THE CITY OF KEY WEST

Tree Commission

STAFF REPORT

RE: Key West Historic Seaport (permit application # T18-8977)

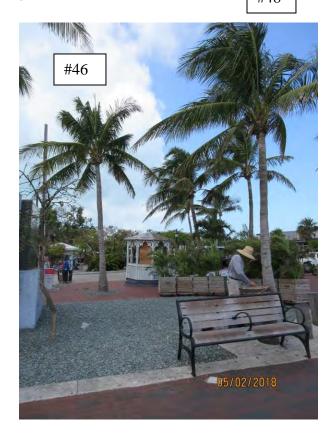
Why do Palms #3, 4, 5, and 6 need to be removed? Transplanting may cause a mess and a great disturbance to the area.

Same for why palms #7 and 8 in that same line of palms, are slated for removal?

Palms #46 and #48 if they can not remain, should be transplanted.

Palm #38 is too tall to be transplanted and due to its condition, would be a candidate for removal.

Geiger tree #10

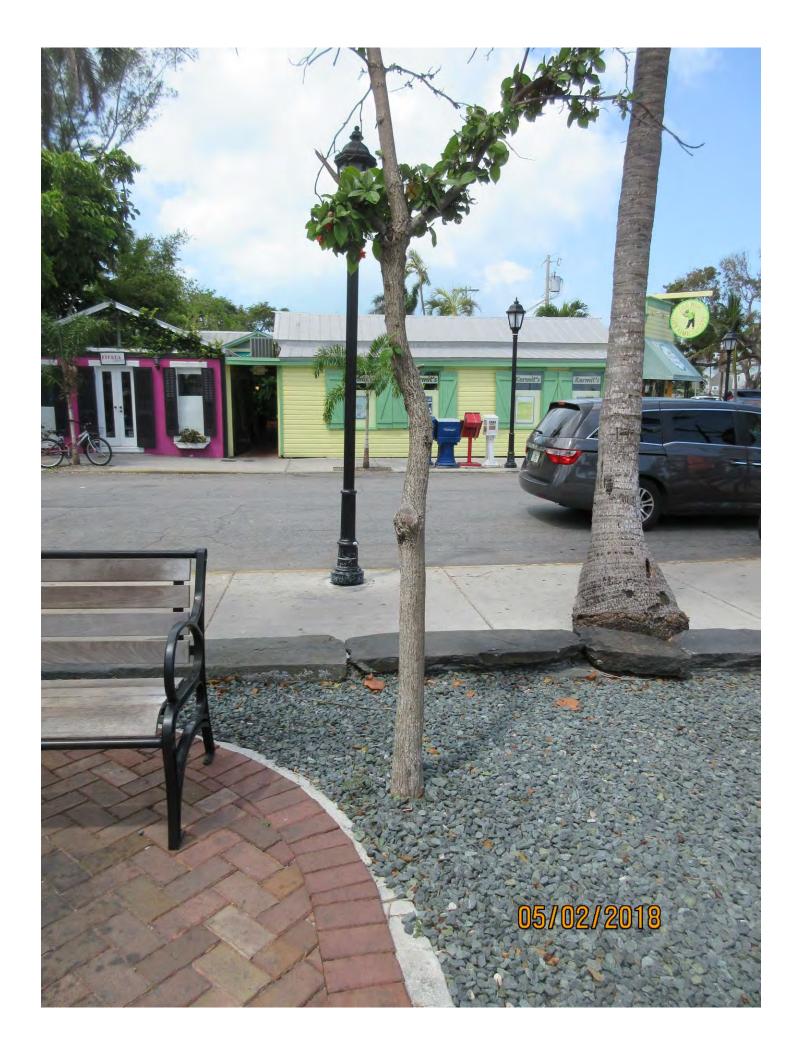
Diameter: 4.7" Location: 100%

Species: 100% (on protected tree list)

Condition: 50% (fair to poor-poor structure, tear in main trunk)

Total Average Value = 83%

Value x Diameter = 3.9 replacement caliper inches

Geiger tree #40 05/02/2018

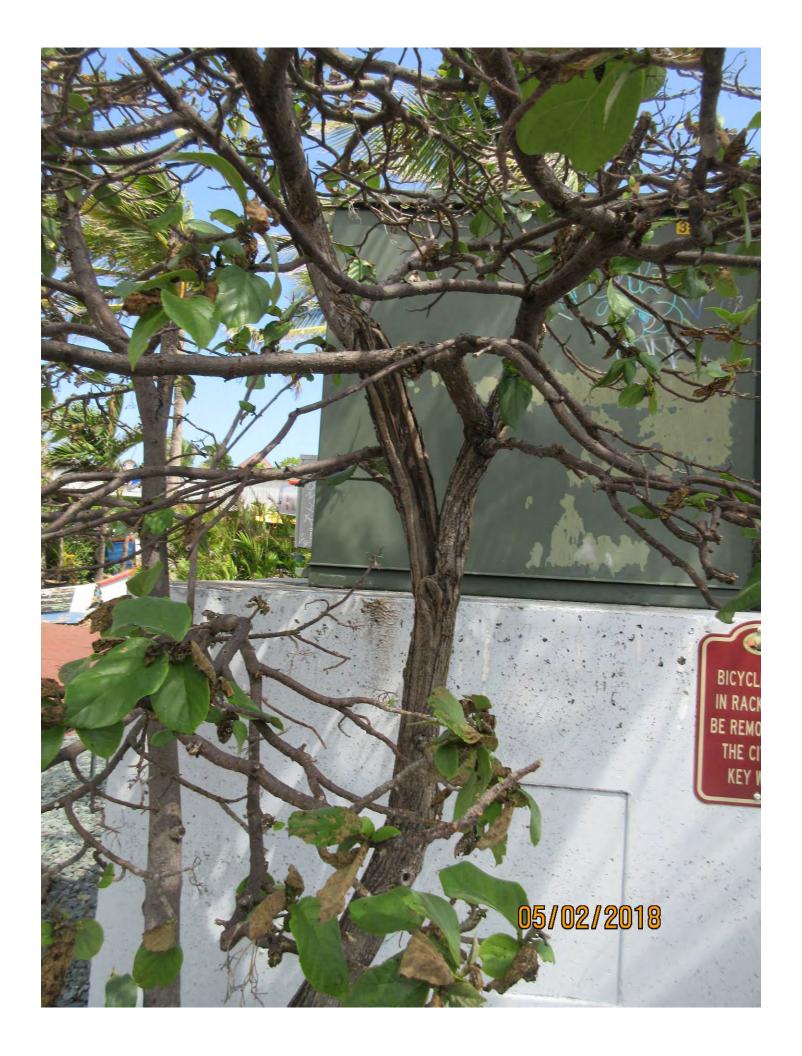
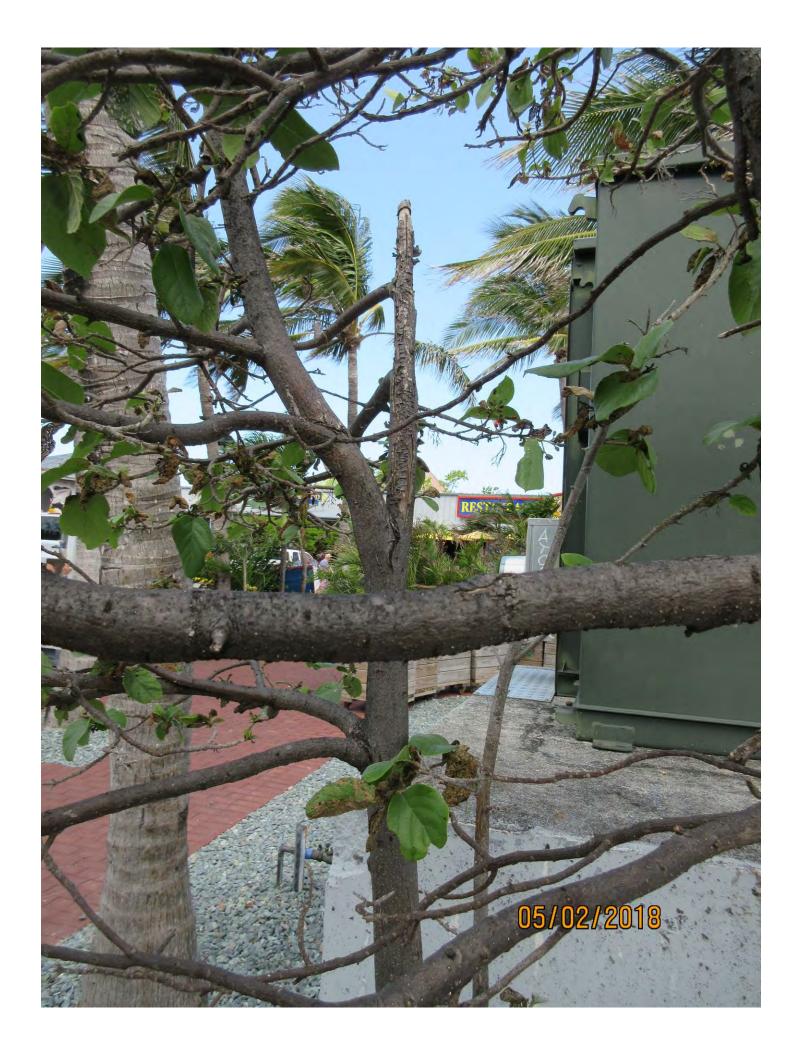
Diameter: 4.1" Location: 100%

Species: 100% (on protected tree list)

Condition: 40% (poor)

Total Average Value = 80%

Value x Diameter = 3.2 replacement caliper inches

Geiger tree #47 05/02/2018

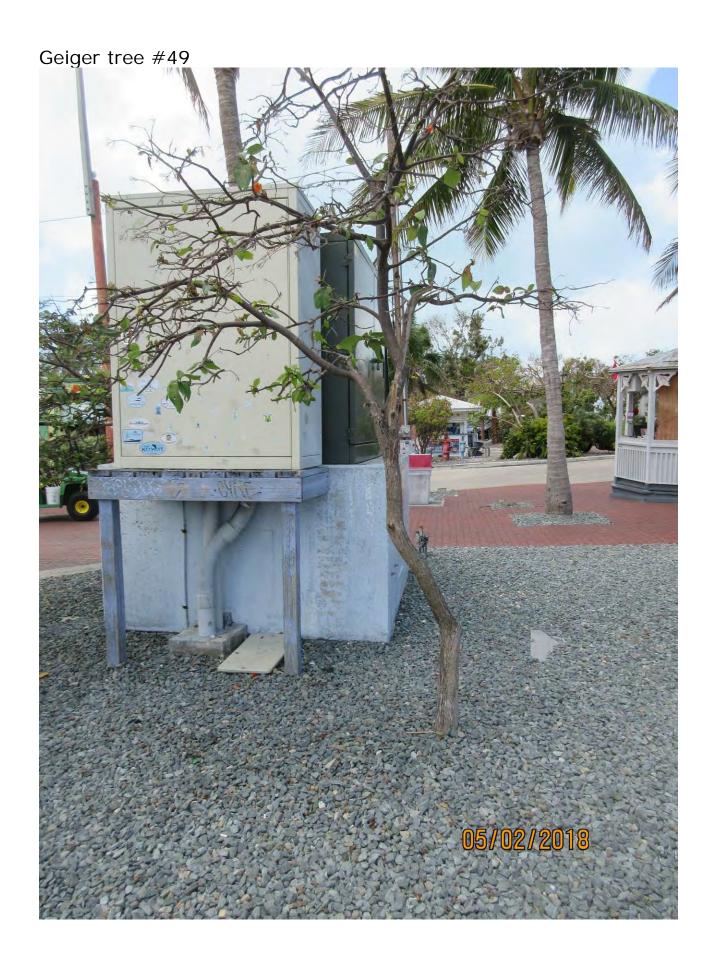
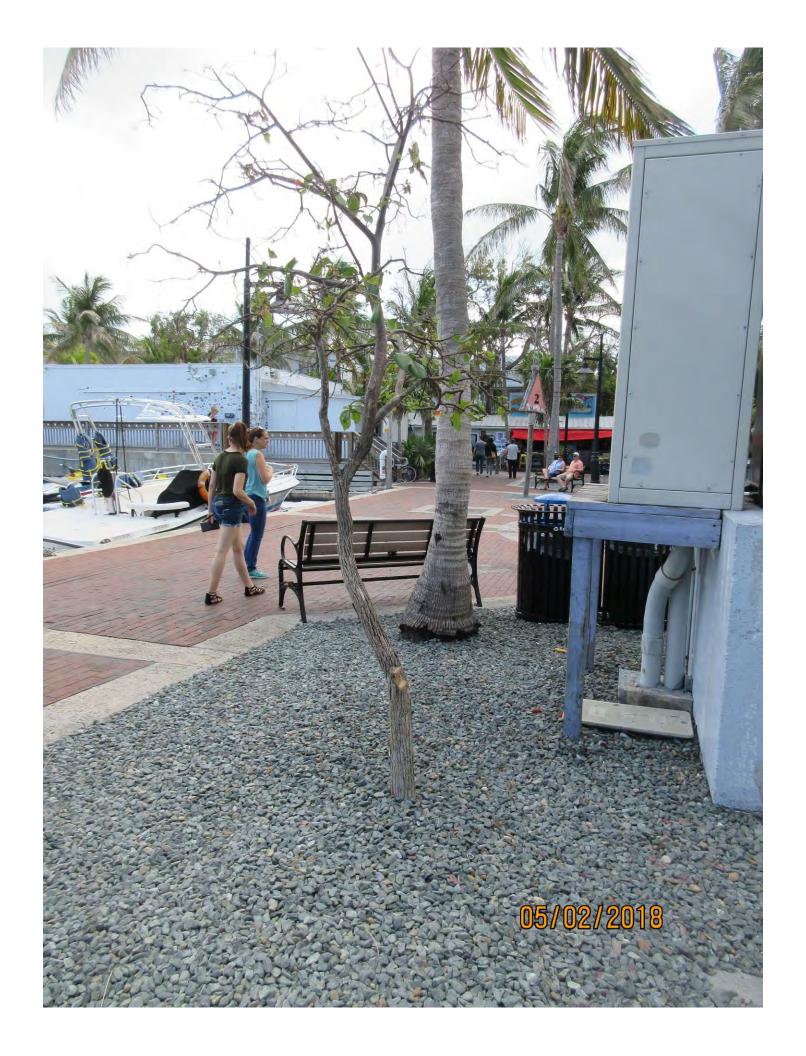
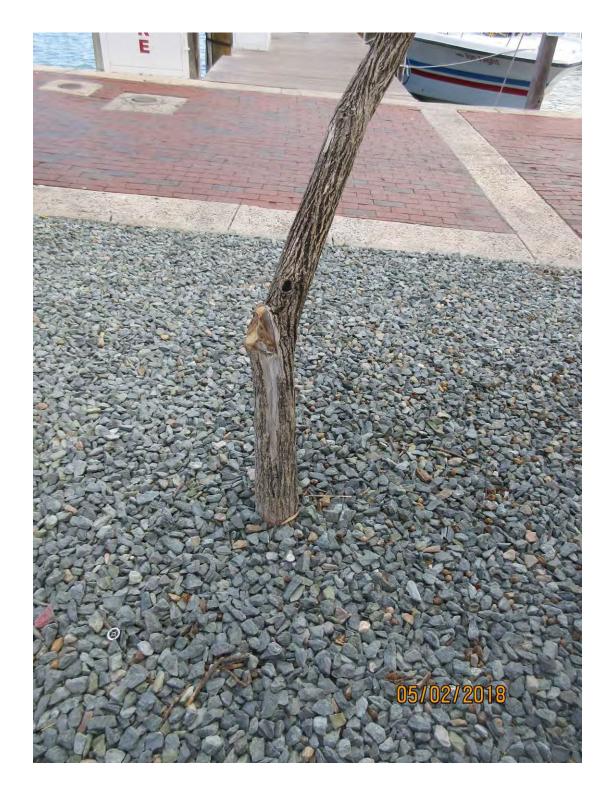
Diameter: 6.2"

Location: 70% (planted close to utility box)

Species: 100% (on protected tree list)

Condition: 50% (fair to poor, poor structure-decay)

Total Average Value = 73%

Value x Diameter = 4.5 replacement caliper inches

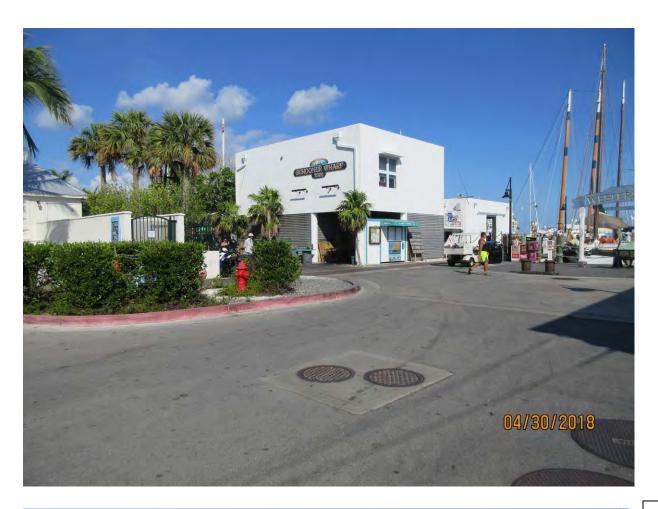
These are some of the Thatch palms that are to be transplanted (where to?).

These Christmas Palms are proposed to be removed. It appears that shrubs will be replanted in this area. Do not recommend removal of these palms. Why do they need to be moved from this area? At the very least, transplant these trees to another location, either in the area or a street planter in old town.

This Thatch Palm is not noted on the plans but is in the project boundaries.

Only shrubs and groundcover are to be added to this proposed work area. Do not recommned the planting of saw palmetto.

Area #3 Margaret Street Plaza

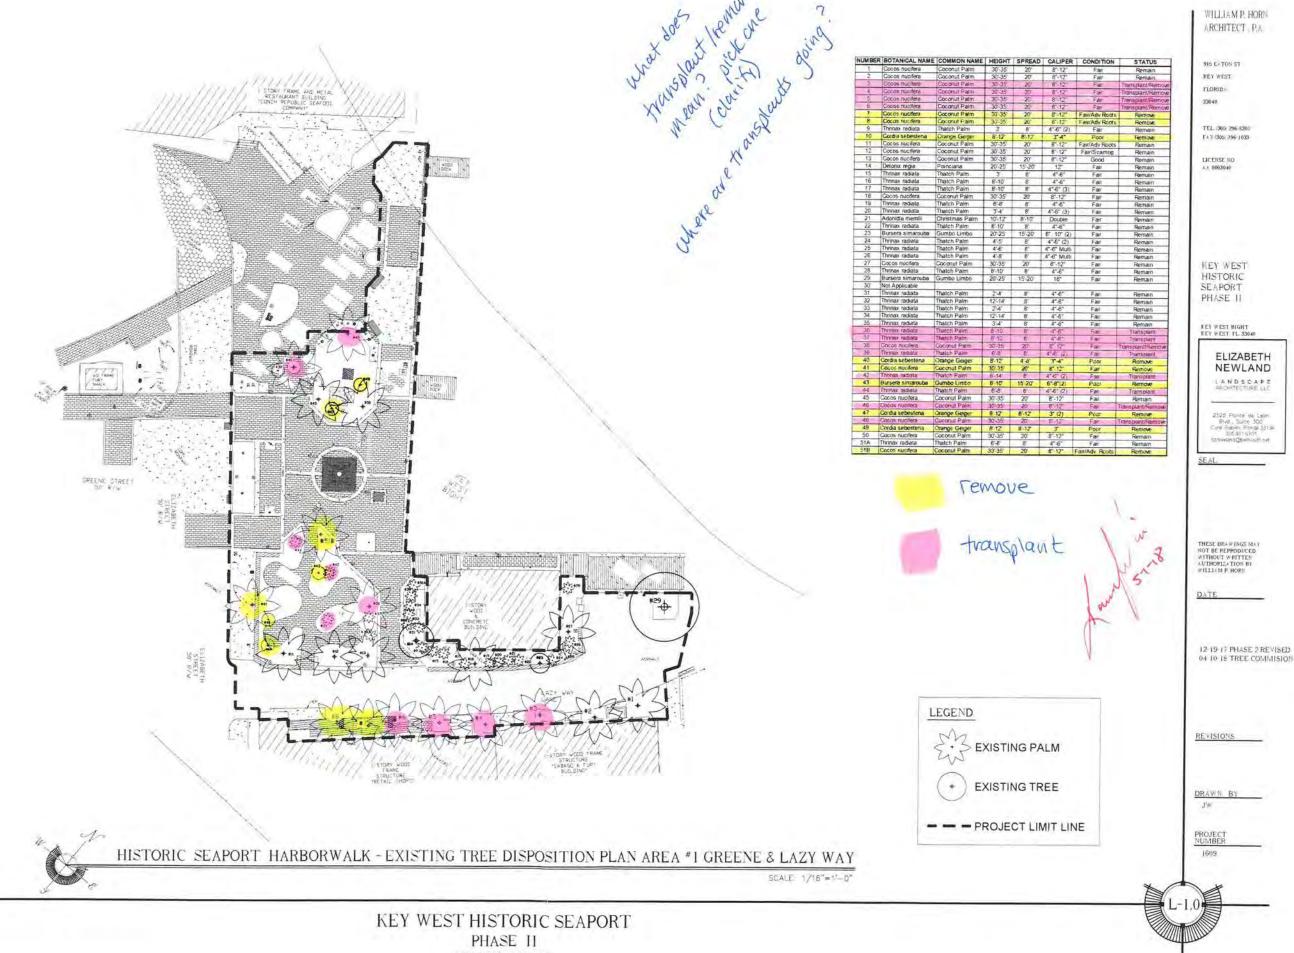
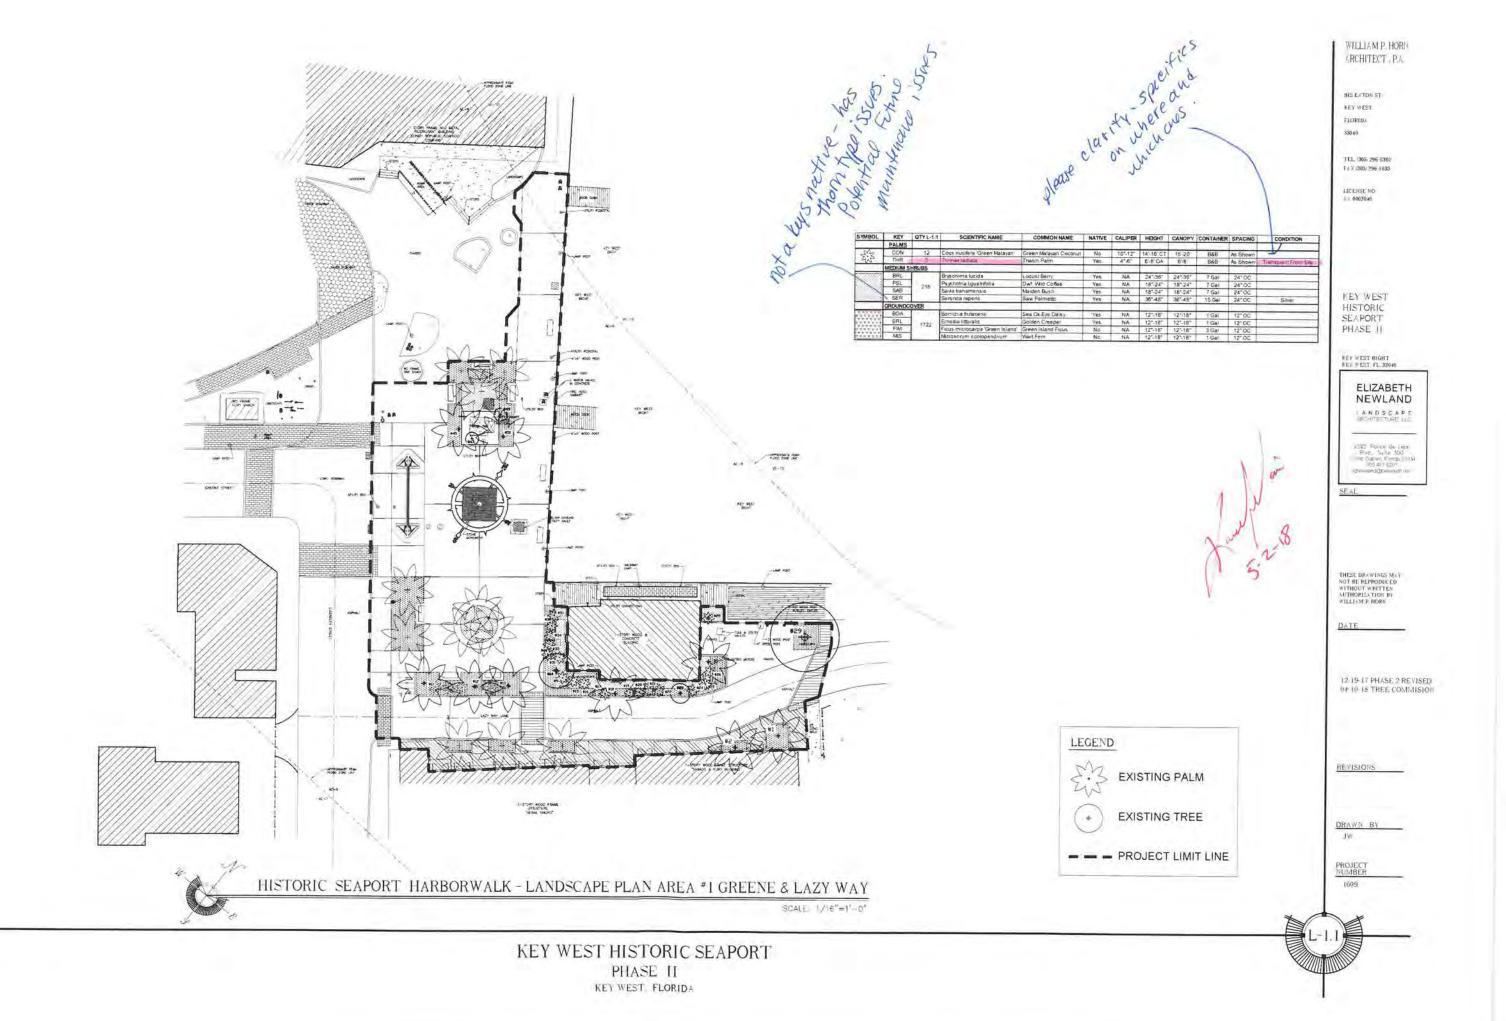
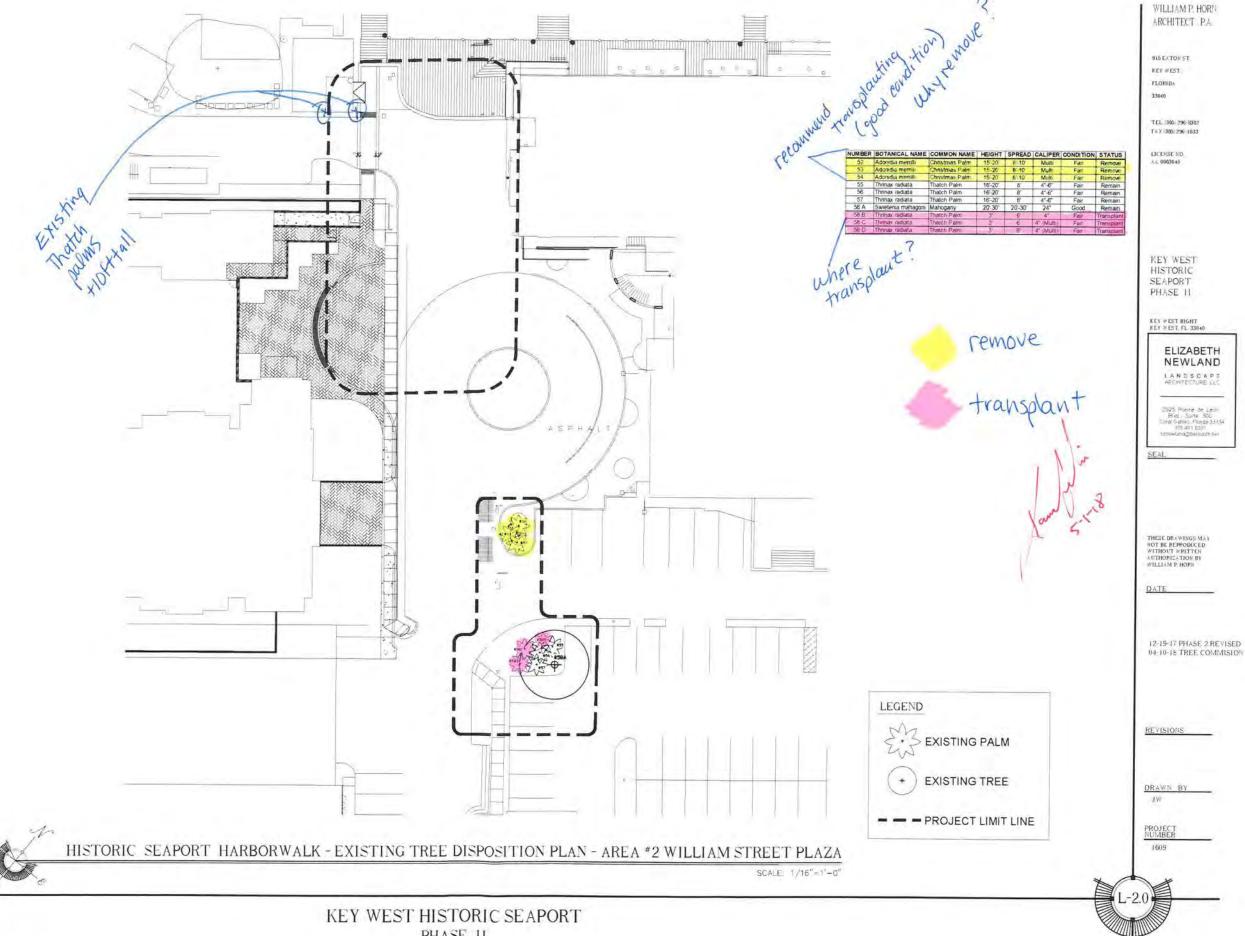
The landscape plan proposes to add tree planters with Pigeon Plum trees along the Margaret Street store front area. Would possibly like to see two or three different species of trees instead of all seven new trees being the same species or is there a certain look for the area that is being developed? The landscape plan says Thatch palms will be transplanted into this area. Where from and where on the plans?
